Memorandum Department of Planning & Public Works

To: Planning and Public Works Committee
From: Annissa McCaskill-Clay, Lead Senior Planner
Date: 06/04/2009
RE: **P.Z. 03-2009 Four Seasons, Lot 3, Plat 6 (Schuyler Corporation):** A request for a change of zoning from "C8" Planned Commercial to "PC" Planned Commercial for a 2.35 acre shopping center located at 13700-13732 Olive Boulevard, on the south side of Olive Boulevard, directly across from the intersection of Olive Boulevard and River Valley Drive. (LOCATOR NUMBER 16Q230260)

Planning Commission Staff Report

Petition: P.Z. 03-2009 Four Seasons, Lot 3, Plat 6 (Schyler Corporation)

PRELIMINARY DEVELOPMENT PLAN
 13700 OLIVE BOULEVARD
 CHESTERFIELD, MISSOURI 63017

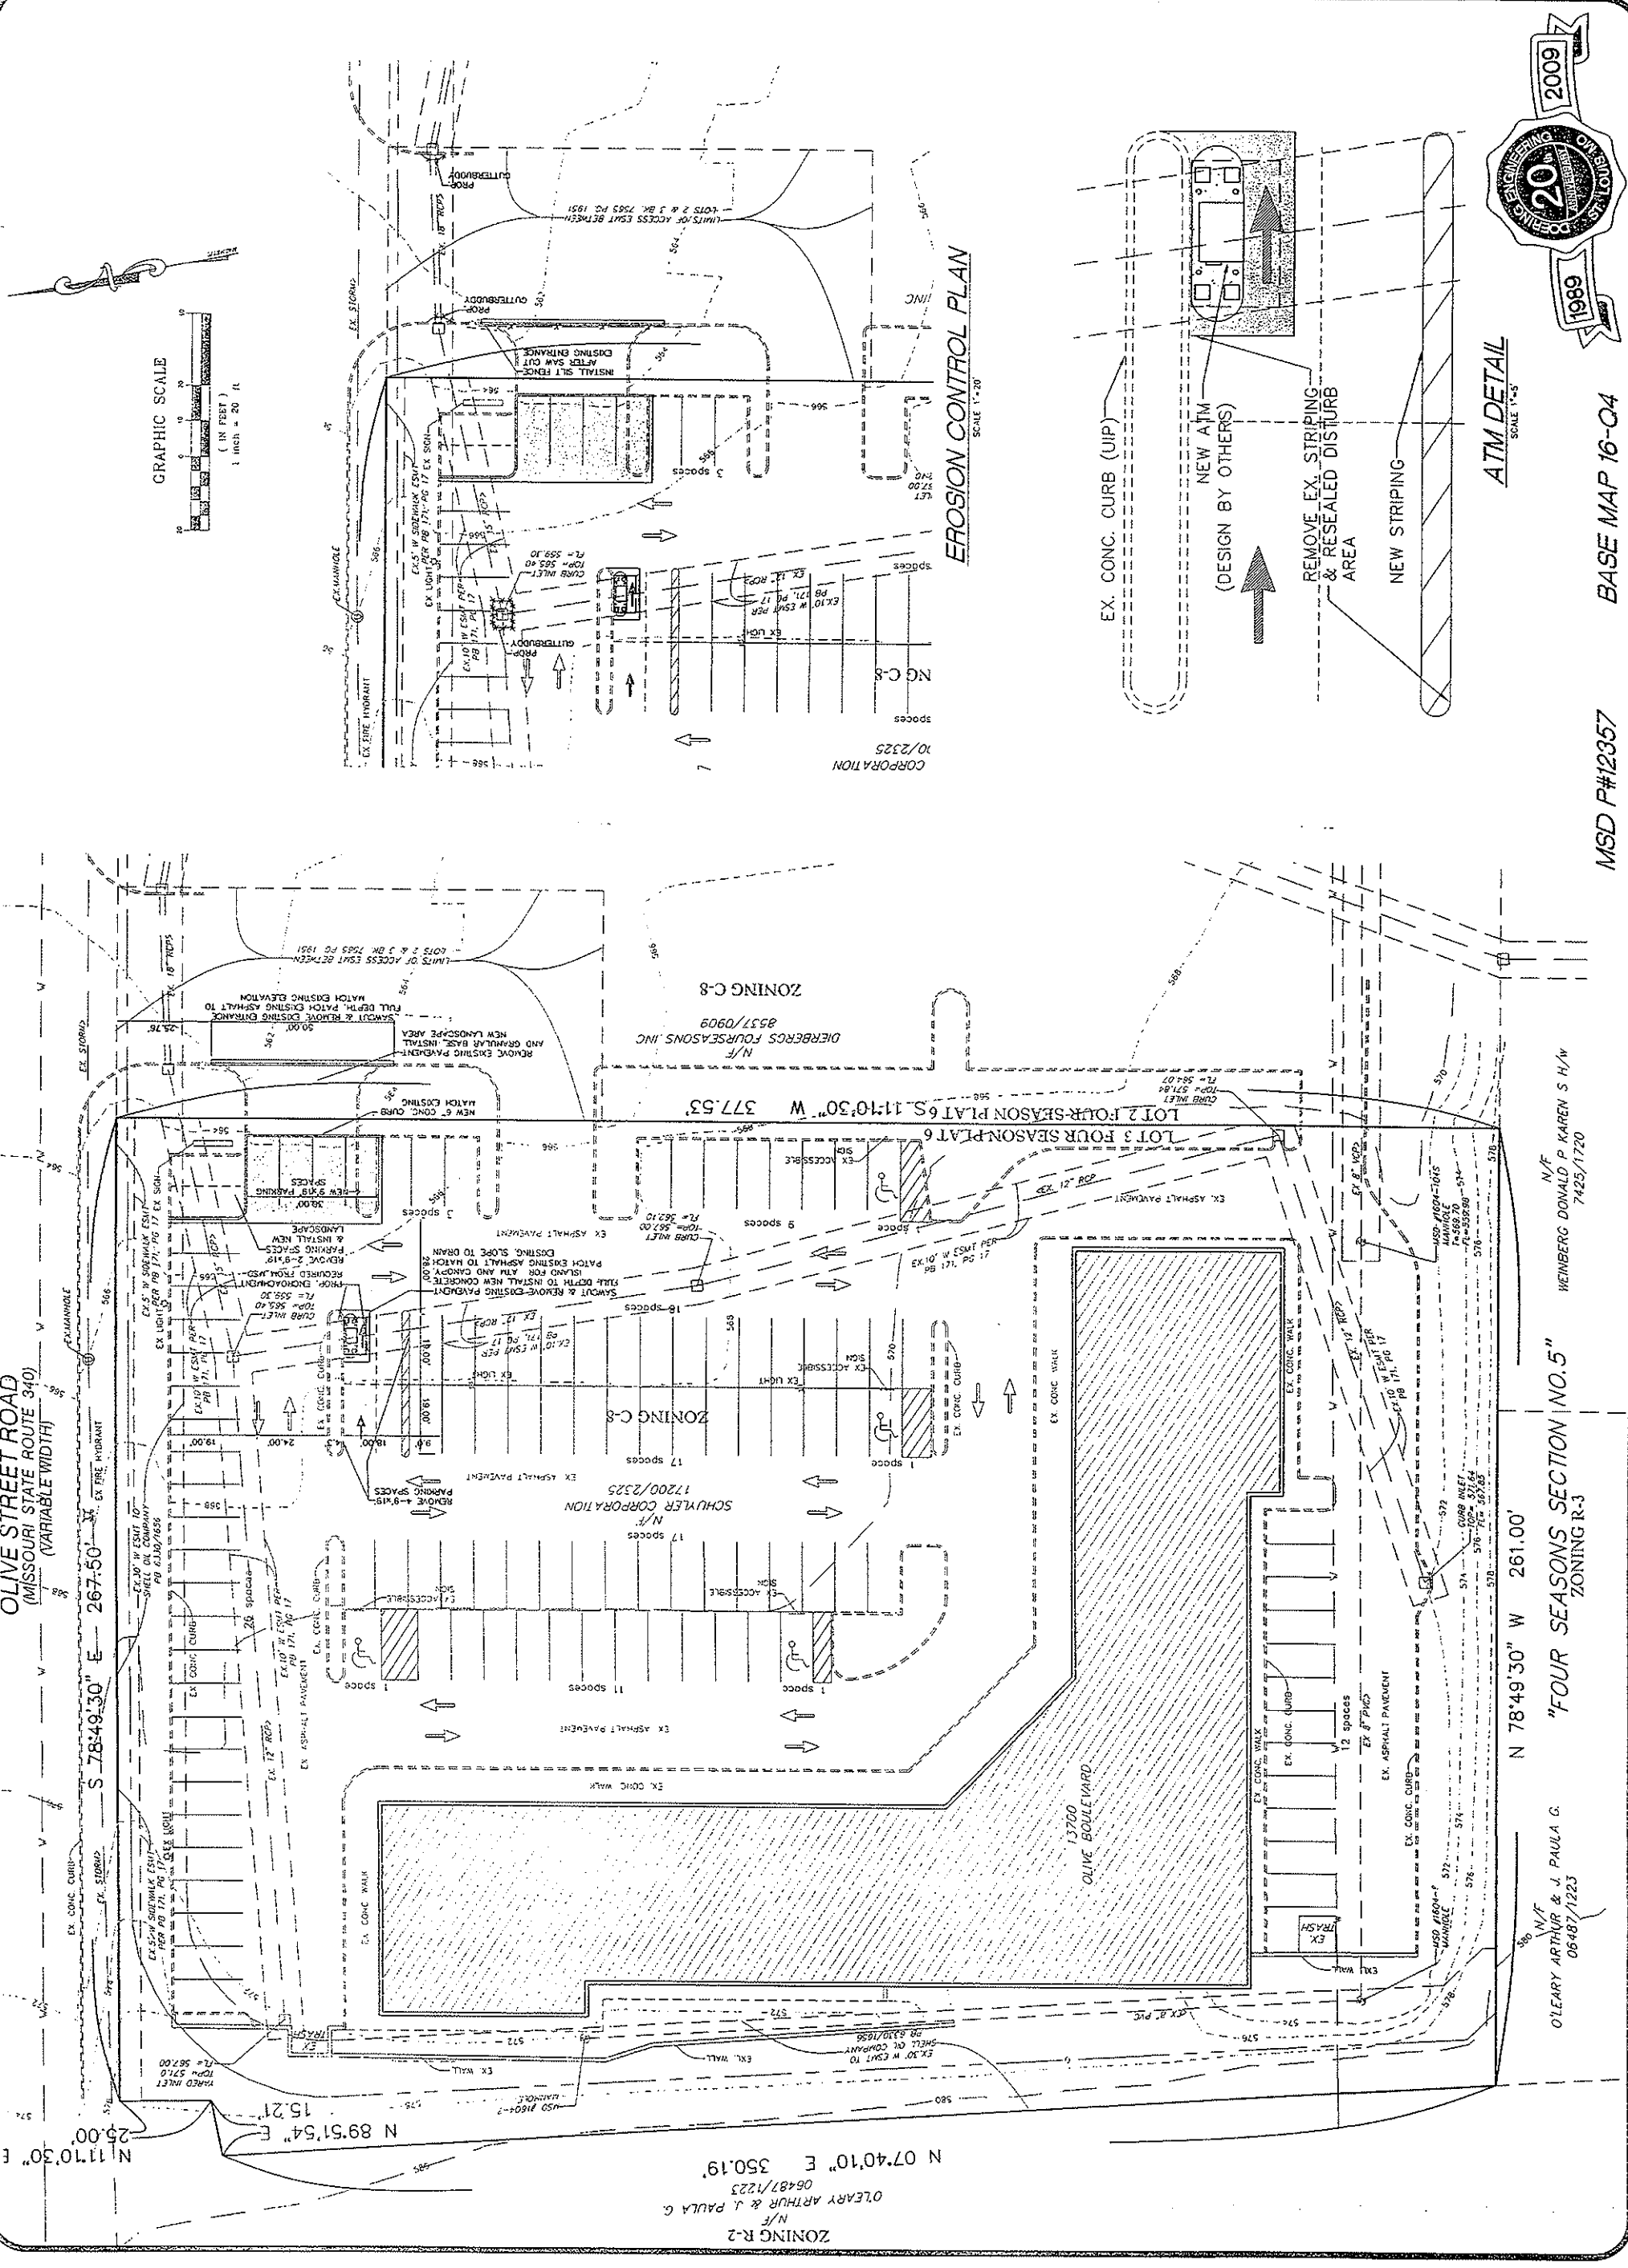
1. Closure of the northernmost entrance to the site.

Petitioner's Response: It is our understanding that pursuant to your discussions with Dave Nichols of the Monarch Fire District, that the north entrance is to be closed and that the parking lot is to be designed such that emergency vehicles can get direct access to the north end of the building. The Petitioner is agreeable to these terms.

2. Per the direction of the City Attorney, the Department of Planning and Public Works officially advises that we have reviewed the current restriction of drive-thru facilities to the easternmost portion of the existing building. We have determined that this location may be problematic in regards to the City of Chesterfield's access management requirements. Therefore, reference to an exact location for *any* drive-thru facilities will not be written into the Attachment.

Petitioner's Response: Petitioner is agreeable to not referencing an exact location for any drive-thru facilities into the Amendment.
